APPLICATION NO.	FILING DATE	FIRST NAMED INVENTOR	ATTORNEY DOCKET NO.	CONFIRMATION NO.
10/591,320	06/02/2007	Akira Tsuboi	107348-00603	9440
4372 7590 04/15/2010 ARENT FOX LLP 1050 CONNECTICUT AVENUE, N.W. SUITE 400 WASHINGTON, DC 20036			EXAMINER DODD, RYAN P	
			ART UNIT 3655	PAPER NUMBER
			NOTIFICATION DATE 04/15/2010	DELIVERY MODE ELECTRONIC

Office Action Summary	Application No.		Applicant(s)	
	10/591,320		TSUBOI ET AL.	
	Examiner		Art Unit	
	RYAN DODD		3655

DETAILED ACTION

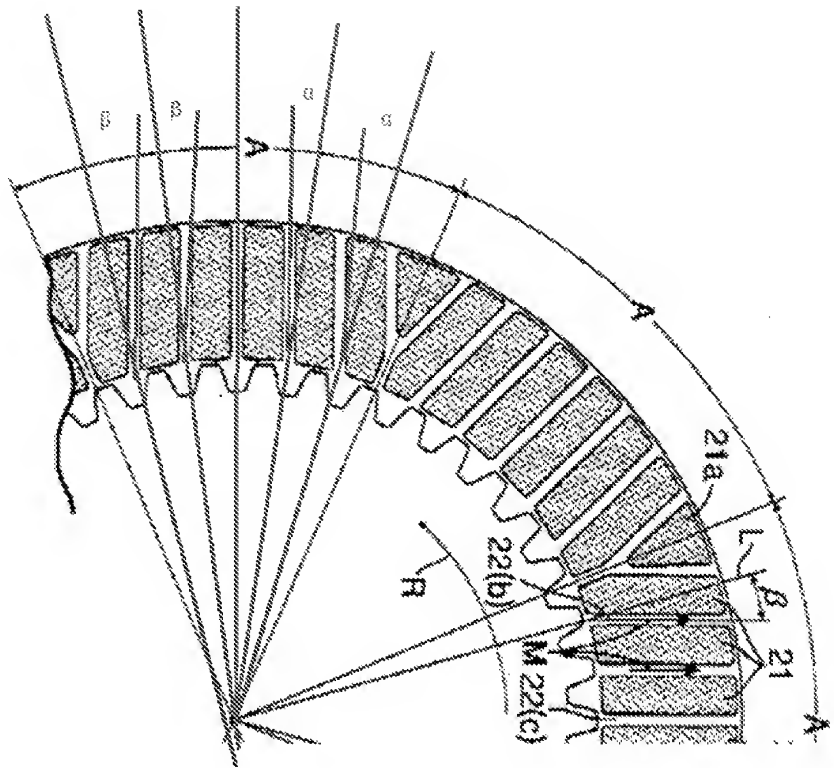
In Applicant's disclosure, on page 2, lines 27-29, of the specification, Applicant discloses one oil channel and another oil channel that are positioned at opposite end parts in the peripheral direction of each region are given the discharge angle and the inflow angle respectively (See also figs. 2-4). However, on page 3 lines 2-3, applicant discloses that it is possible to easily form the **plurality of oil channels having an inflow angle and a discharge angle**, implying that all oil channels have such an angle. Also in claim 1, lines 10-11, Applicant claims a "plurality of oil channels including a plurality of discharge oil channels having a discharge angle (β) relative to a radial line (L)", and in lines 14-16, Applicant claims a "the plurality of oil channels further include a plurality of inflow channels having an inflow angle (α) relative to the radial line (L) of the friction plate."

It is clear that applicant is claiming a plurality of inflow channels and discharge channels relative to a radial line (L). The problem is that a radial line (L) can be drawn to any of the plurality of inflow and discharge oil channels, resulting in multiple diverse inflow and discharge angles being realized (See figure below). It therefore contradicts the assertion in claims 4-6 that "the discharge angle (β) is equal to the inflow angle (α)", because there are multiple diverse discharge and inflow angles, and not all discharge angles are equal to all inflow angles.

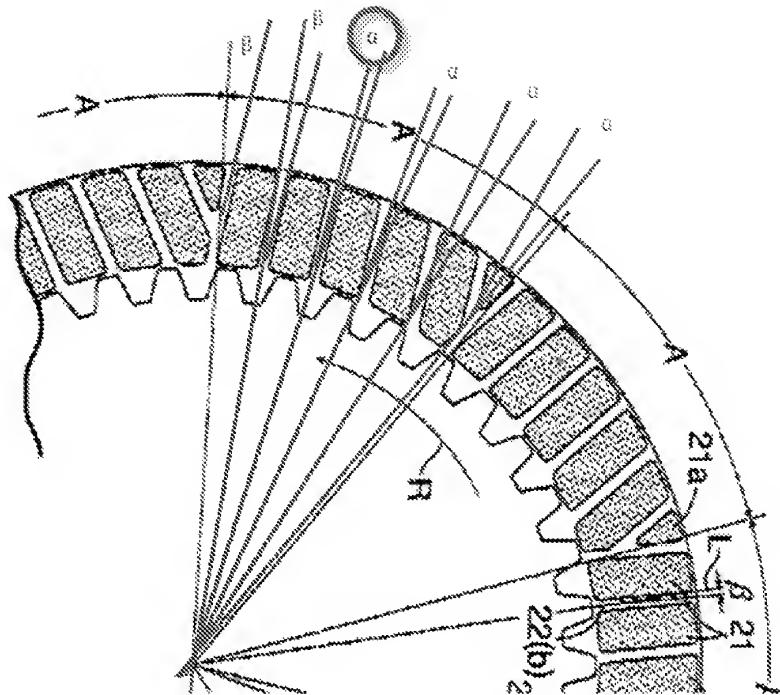
inflow angle respectively (See also figs. 2-4). However, on page 3 lines 2-3, applicant discloses that it is possible to easily form the plurality of oil channels having an inflow angle and a discharge angle, implying that all oil channels have such an angle. Also in claim 1, lines 10-11, Applicant claims a "plurality of oil channels including a plurality of discharge oil channels having a discharge angle (β) relative to a radial line (L)", and in lines 14-16, Applicant claims a "the plurality of oil channels further include a plurality of inflow channels having an inflow angle (α) relative to the radial line (L) of the friction plate."

It is clear that applicant is claiming a plurality of inflow channels and discharge channels relative to a radial line (L). The problem is that a radial line (L) can be drawn to any of the plurality of inflow and discharge oil channels, resulting in multiple inflow and discharge angles being realized (See figure below). It therefore contradicts the assertion in claims 7-9 that "the discharge angle (β) is less than the inflow angle (α)", because there are multiple diverse discharge and inflow angles, and not all discharge angles are less than all inflow angles. In fact, **it appears to be the inflow angle (circled below) directly adjacent to the discharge angle identified by applicant in fig. 4 that is the smallest angle of them all.**

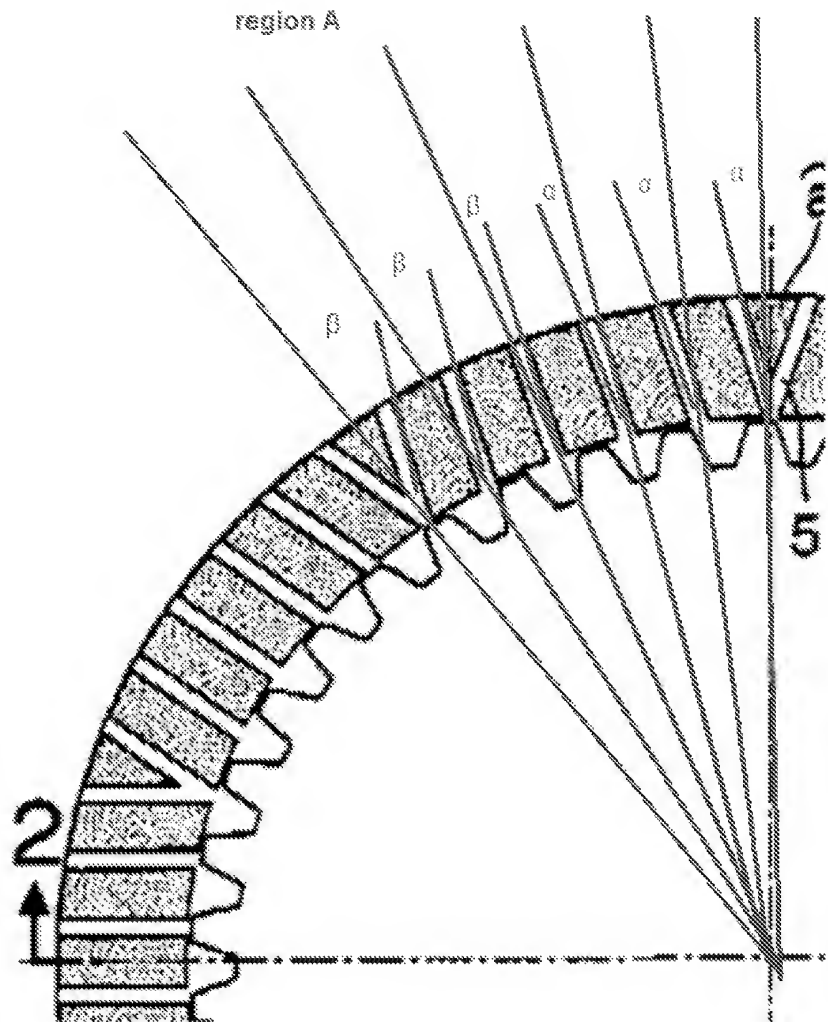
- A wet clutch friction plate comprising:
- friction material (friction member 4) bonded to a side face of a core plate (2),

wherein a plurality of oil channels (oil grooves 5) are defined in the friction material and provide communication between inner and outer peripheral edges of the friction material,

- wherein the plurality of oil channels include a plurality of discharge oil channels having a discharge angle (β) relative to a radial line (L) of the friction plate and which are configured to discharge oil from an inner peripheral side to an outer peripheral side of the friction plate due to a screw pump action that occurs when the friction plate rotates relative to the clutch plate, and the plurality of oil channels further include a plurality of inflow oil channels having an inflow angle (α) relative to the radial line (L) of the friction plate and which are configured to draw oil in from the outer peripheral side to the inner peripheral side of the friction plate due to the screw pump action that occurs when the friction plate rotates relative to the clutch plate (see figure below), and

- wherein the discharge angle (β) inclines rearward relative to the radial line (L) and the inflow angle (α) inclines forward relative to the radial line (L) (see figure below).

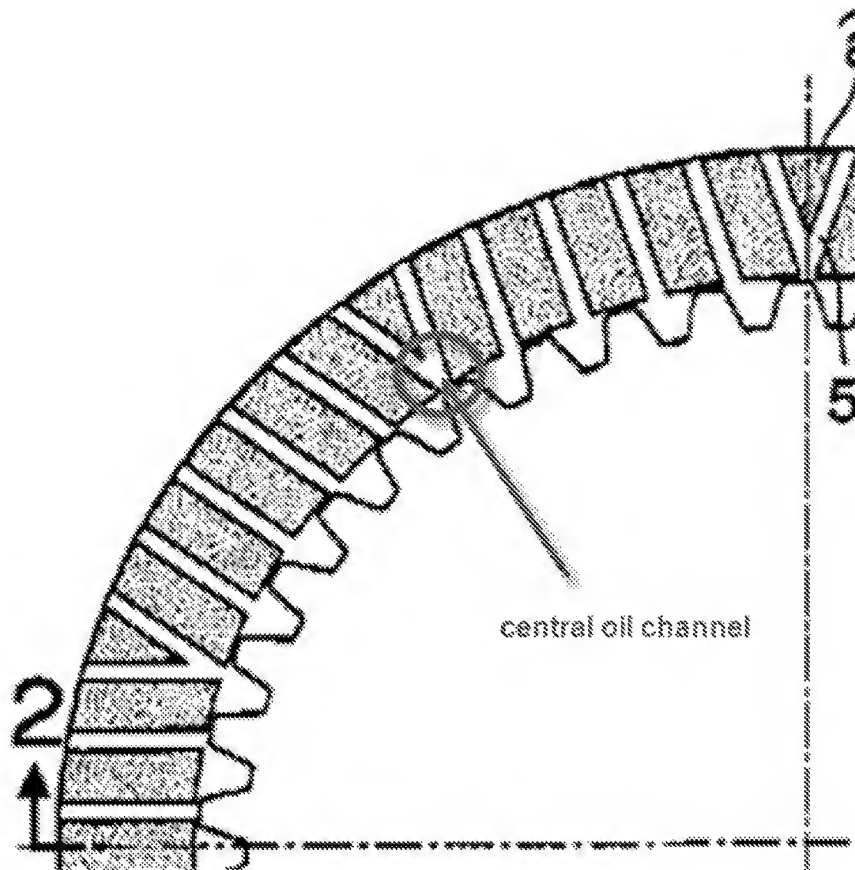
- wherein the friction plate (48) is divided into a plurality of regions (A) arranged in the peripheral direction, each region including an equal number of discharge and inflow oil channels (see figure above).

As to **claims 4-9**, at least one discharge angle of Oguri '783 is equal to at least one inflow angle, and at least one discharge angle is less than at least one inflow angle, as measured from a radial line L (See figure above).
